Title: Advisory Committee on Reactor Safeguards
 Future Plant Designs Subcommittee

Date: Tuesday, March 1, 2016

15 Today we have members of NuScale Power,
16 LLC, otherwise known as NuScale, and the NRO staff,
17 to brief the subcommittee on the NuScale-submitted
18 topical report on risk determination methodology
19 and the NRC staff's review of it and NuScale's plan
20 to use this methodology in their design
21 certification application for their design of the
22 small modular reactor that uses integrated
23 pressurized water reactor technology.

Basis CDF Thresholds

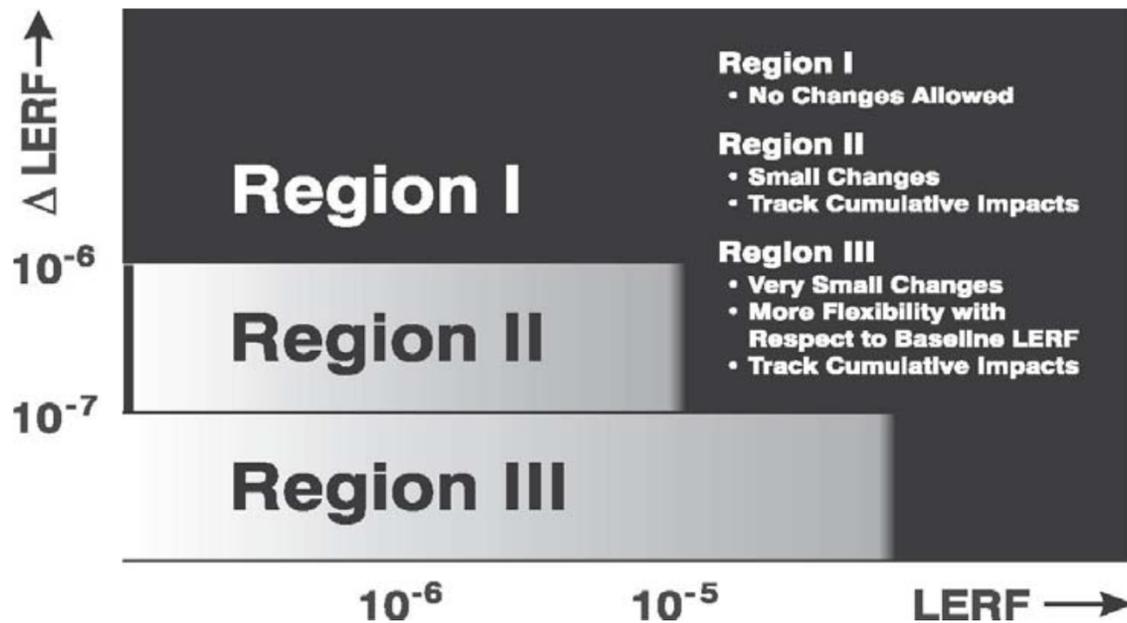
19 CHAIR CORRADINI: So, I'm going to let
20 John understand that answer. I want to go back to
21 in the figure you have, you talk about LERF, but
22 we're talking LRF. So, they're not one in the
23 same.

9 MEMBER STETKAR: Let me try this:
10 Suppose their core damage -- their base core damage
11 frequency is three times 10 to the minus six.
12 Every single component in that plant will then be
13 in their DRAP program, because the conditional core
14 damage frequency by definition if I fail any
15 component, will be greater than three times 10 to
16 the minus six.

1 anywhere. So, for both of you the question would
2 be, how close do you have to be to three times 10
3 to the minus six before you would abandon the
4 suggested approach and move to the old approach?
